**DOCUMENT 00 90 00
ADDENDUM**

ADDENDUM NO. [2] Date: October 10, 2019

**RE: LANESBORO PUBLIC SCHOOLS
 ADDITION AND REMODEL REBID
 100 KIRKWOOD ST EAST
 LANESBORO, MN 55949
 HSR 18063**

**FROM: HSR Associates, Inc
 100 Milwaukee Street
 La Crosse, WI 54603
 (608) 784-1830**

E000

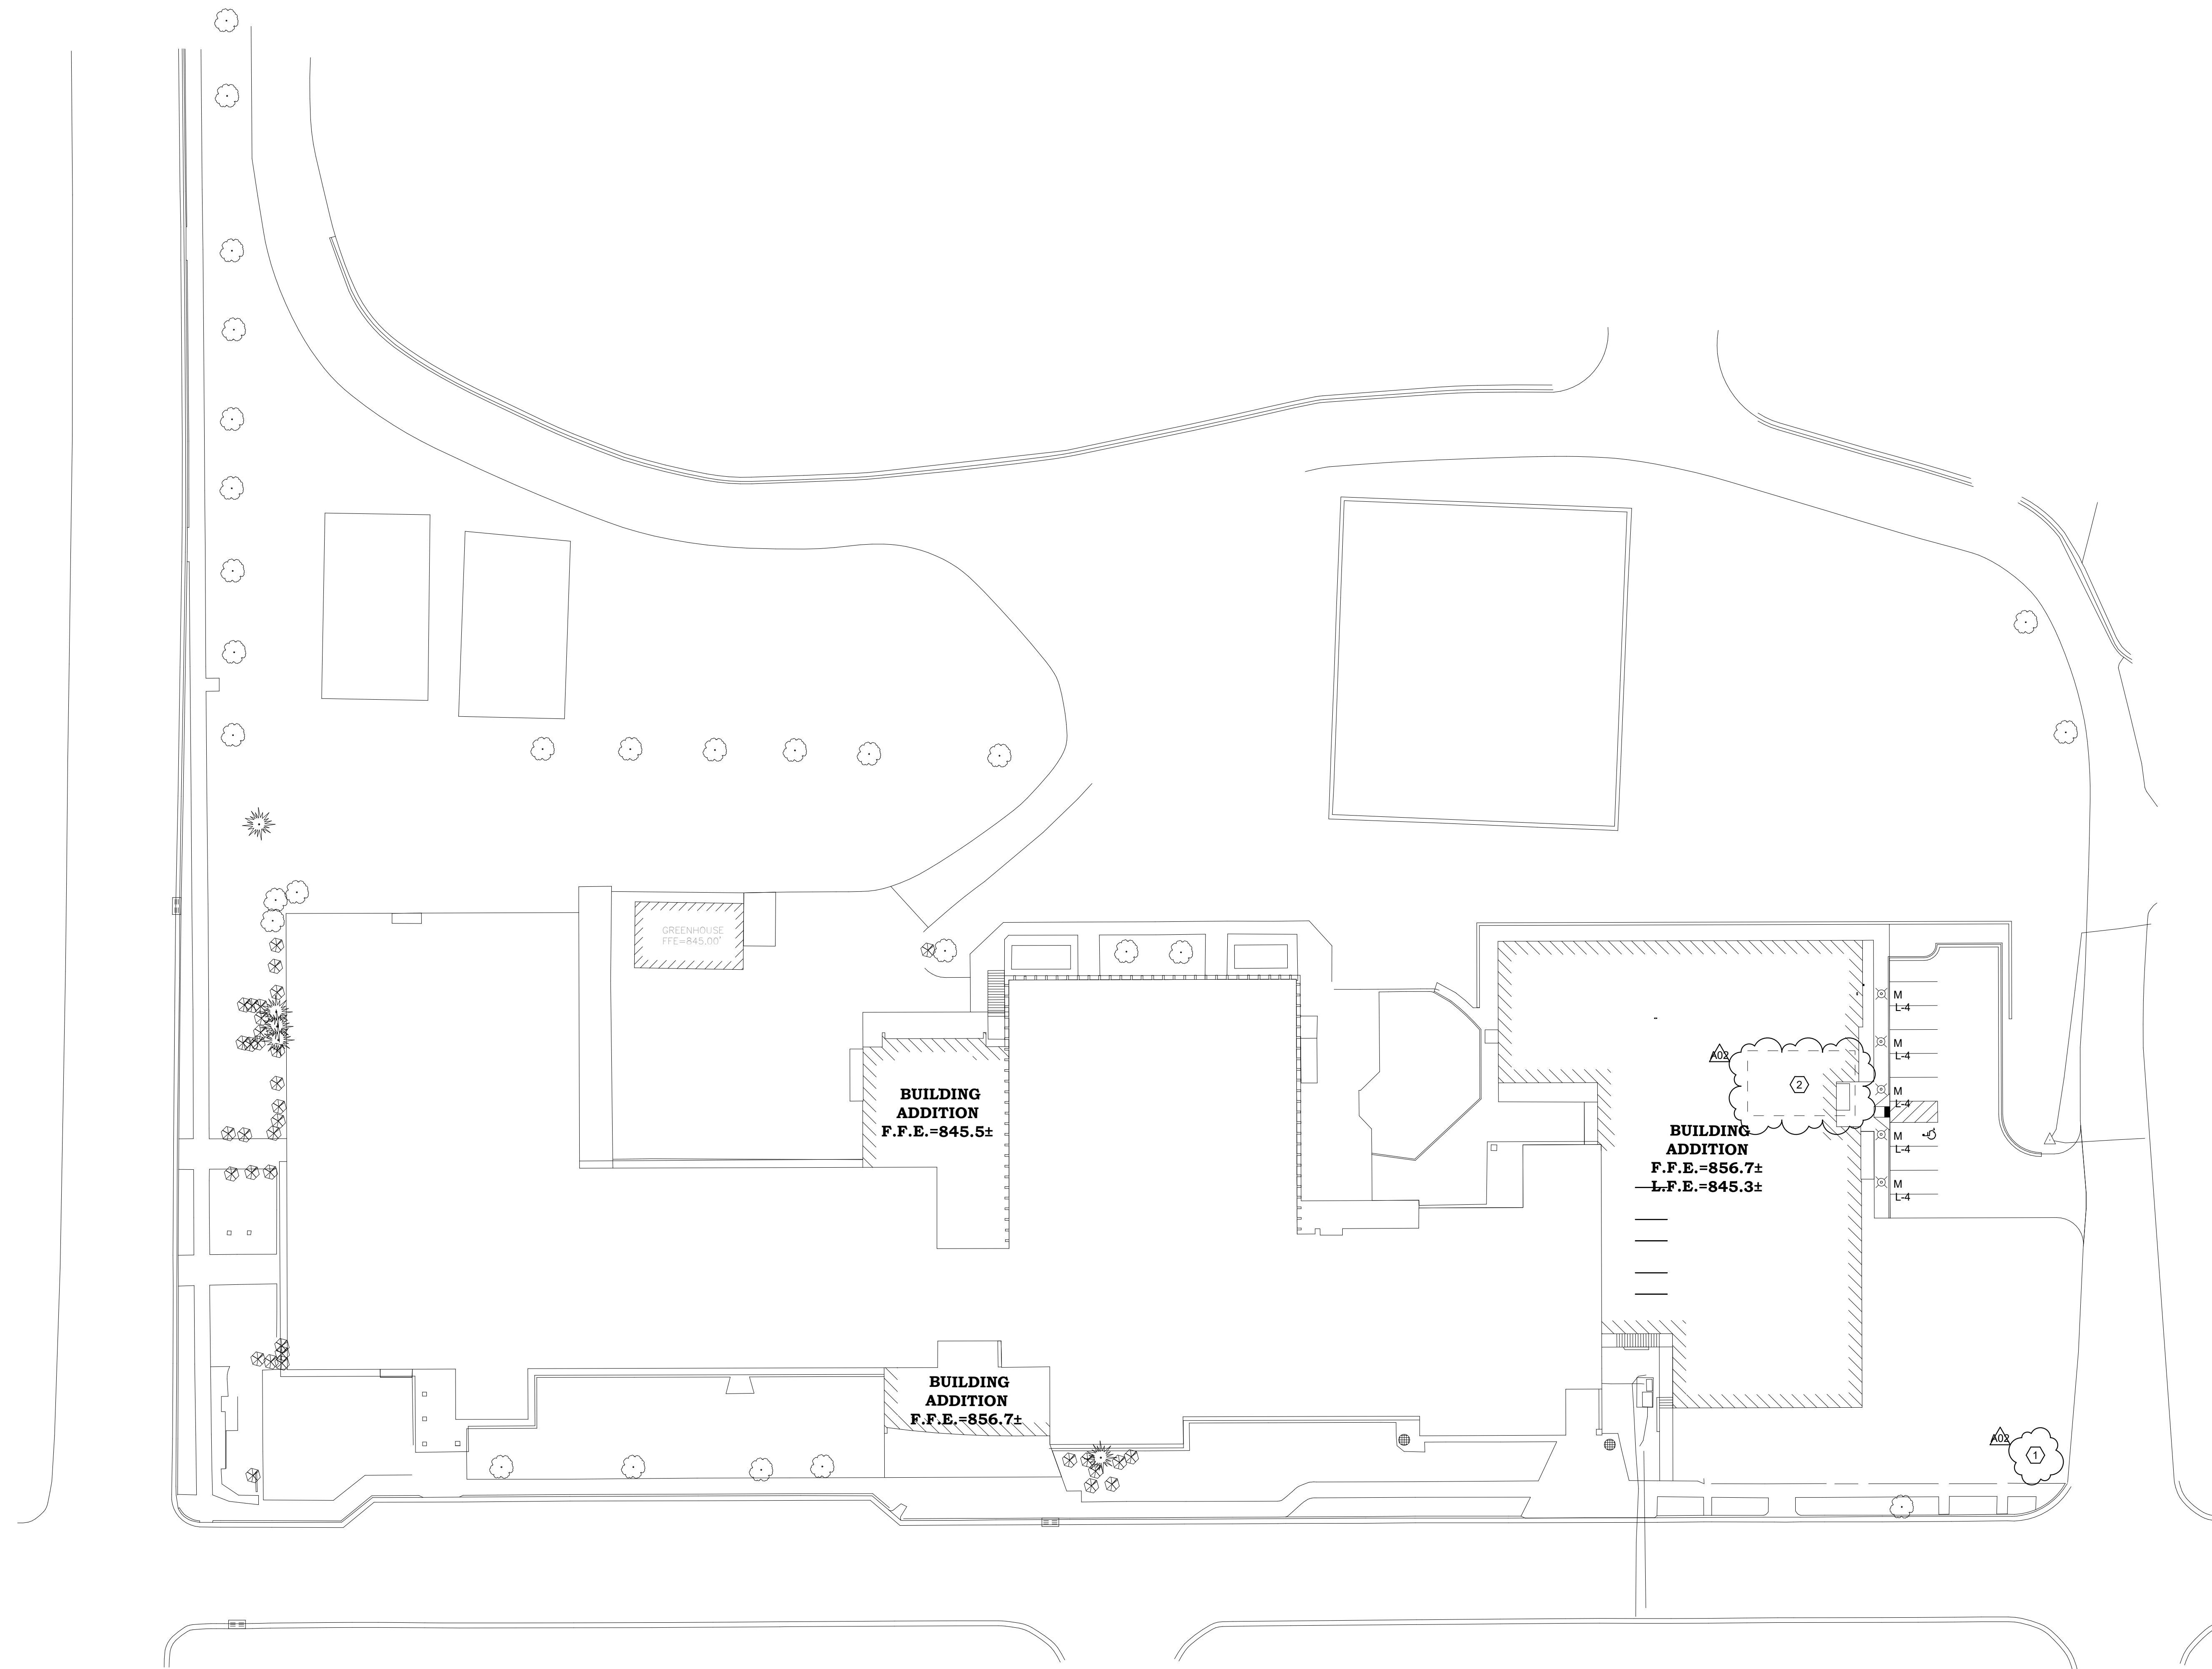
- a. Revisions clouded on Drawing
 - b. Add type 'L' light fixture to luminaire schedule, as shown.
 - c. Add schedule notes to communications device schedule and access control schedule to clarify rough-in only scope, as shown.

E090P

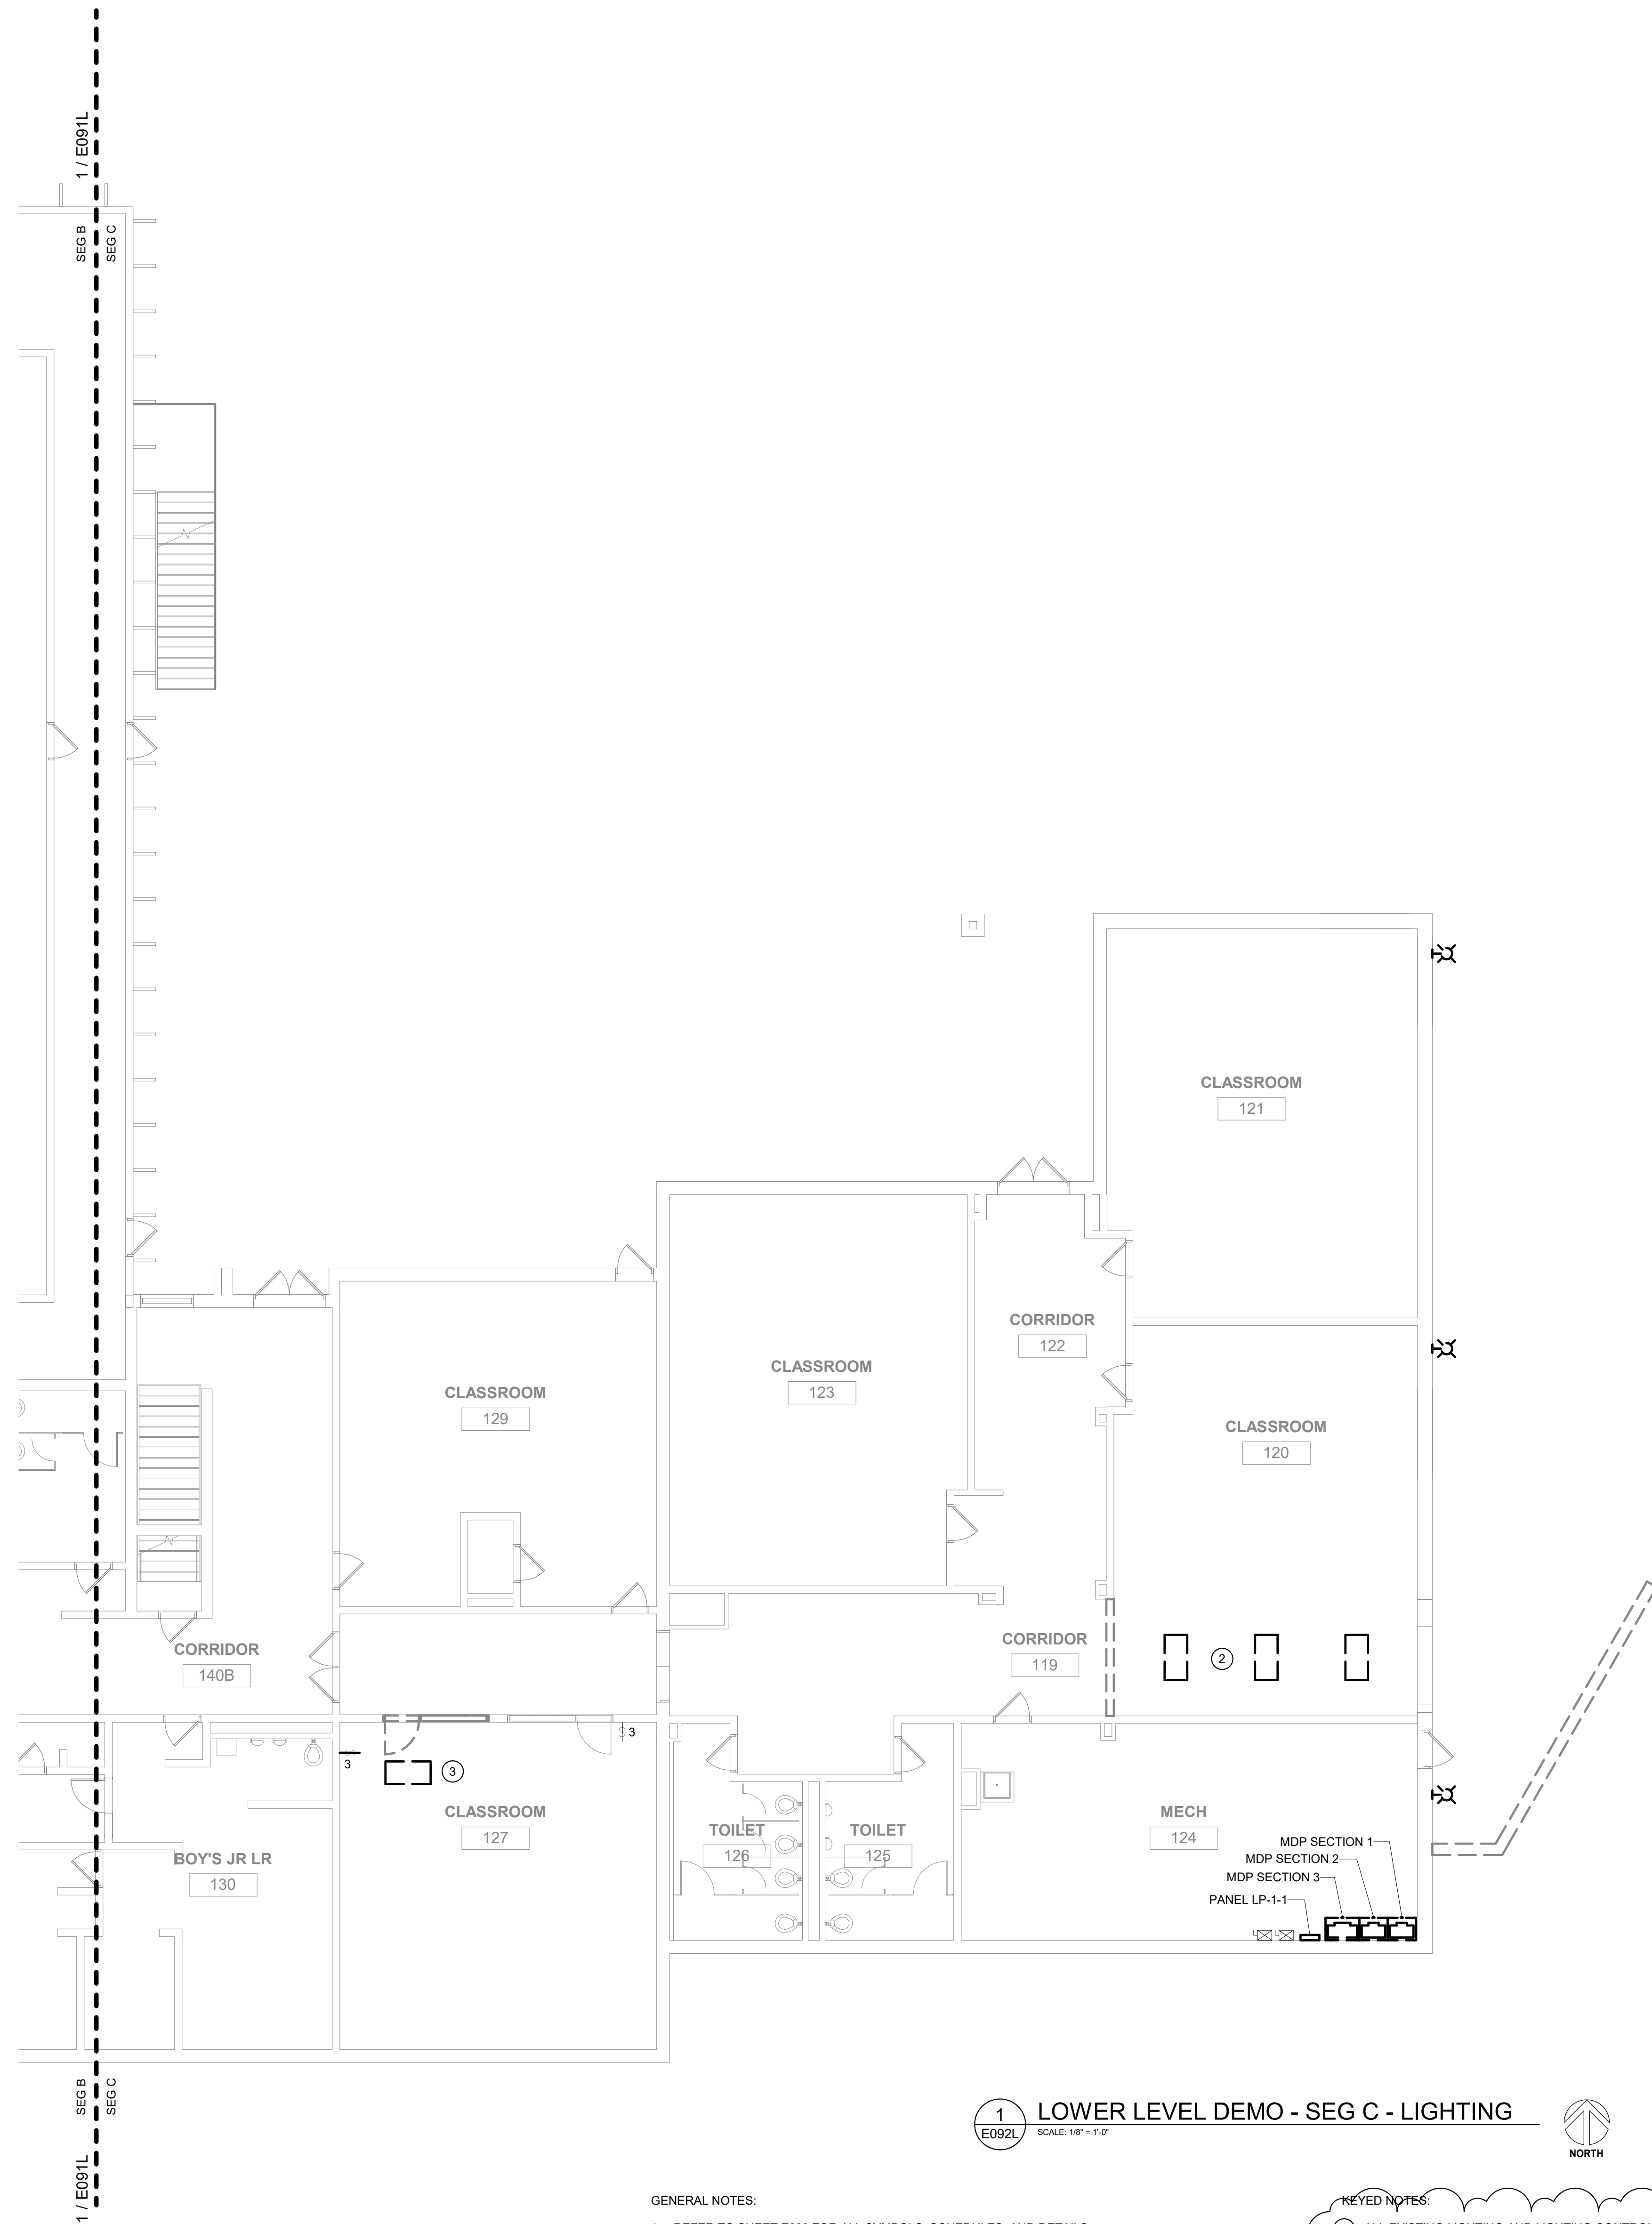
- a. Revisions clouded on Drawing
 - b. Revise keyed note 2 to clarify electrical contractor scope of work for fire alarm, as shown.
53. Sheet E092L – LOWER LEVEL DEMO - SEG C – LIGHTING 30 x 42 attached hereto

E092L

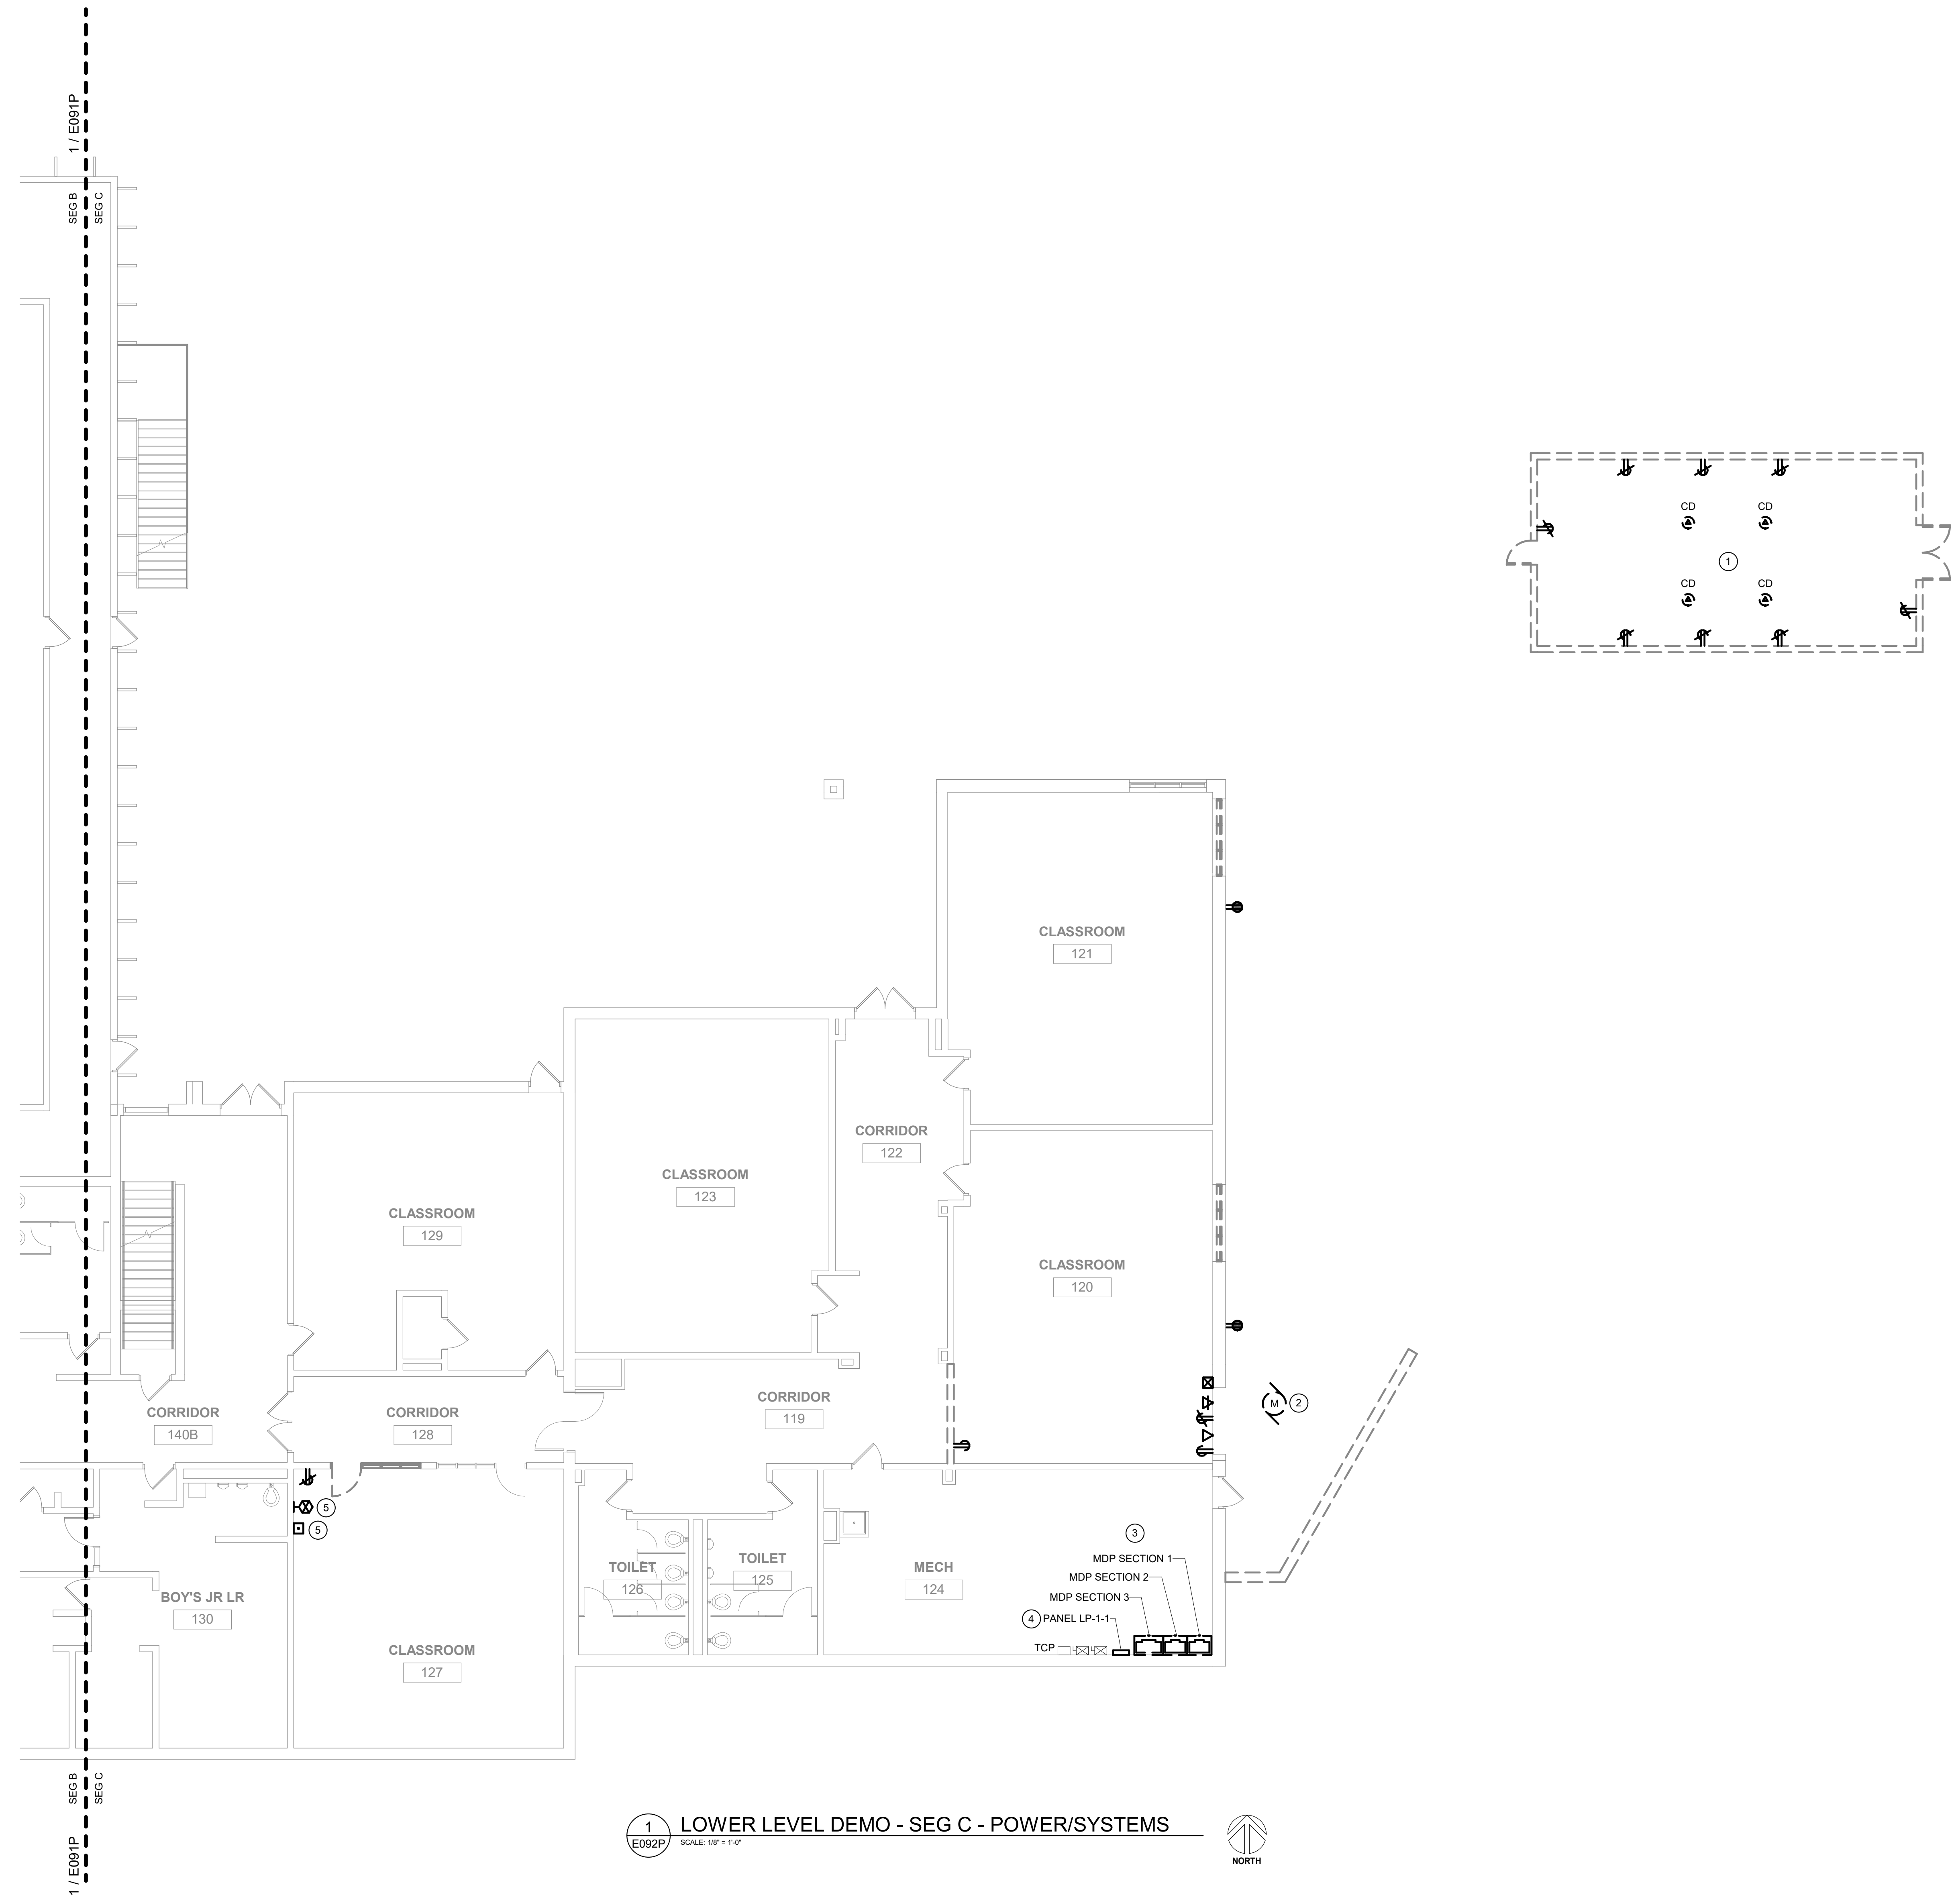
- a. Revisions clouded on Drawing
 - b. Revise keyed note 1 to clarify scope of work to be done for green house relocation, as shown.
54. Sheet E092P – LOWER LEVEL DEMO - SEG C – POWER/SYSTEMS 30 x 42 attached hereto
